XLamp® XP-G LED Product Change Notification

PCN Reference Number: CreeLED-PCN-5308
Date Issued: April 13, 2022

Figure 1 LED Forward Voltage vs Current Curves

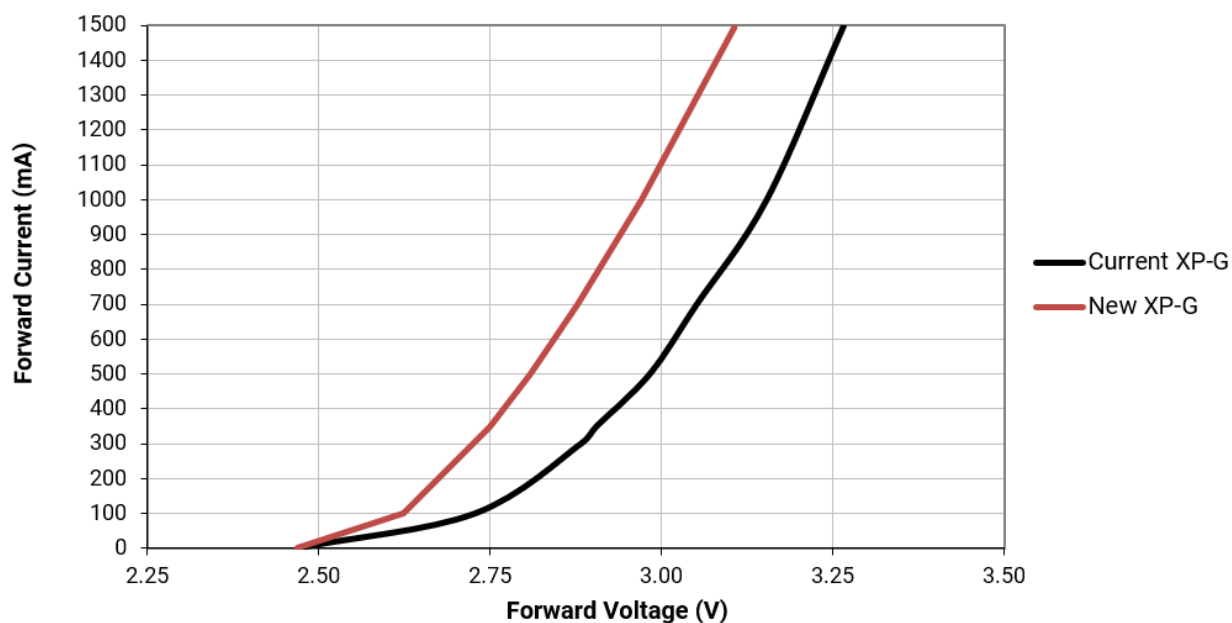
Cree LED will be changing the typical thermal resistance, typical and maximum forward voltage, and typical temperature coefficient of voltage characteristics for the affected XP-G LEDs. Table 2 shows the current and new values.

The following graph shows the improved Forward Voltage vs Current Curves.

Figure 2 XP-G White appearance comparison

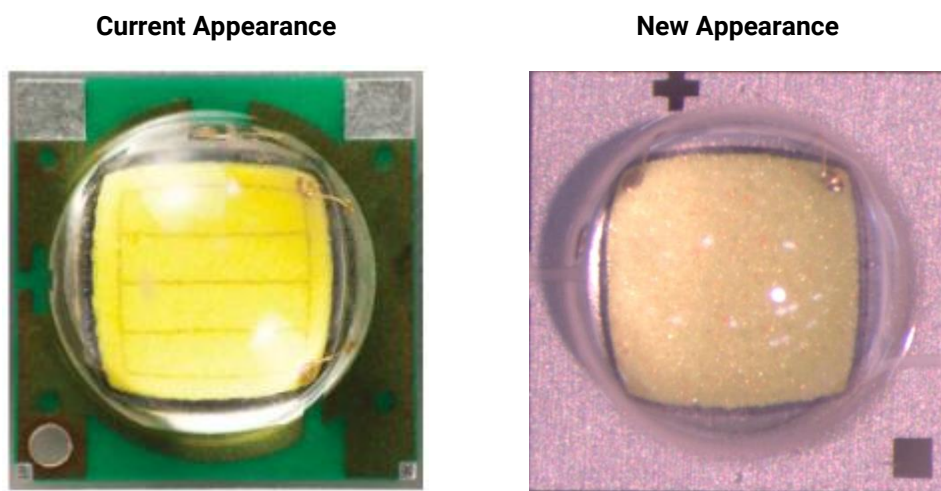
The visual appearance of the LED will change. Examples of the current and new visual appearances are shown below.
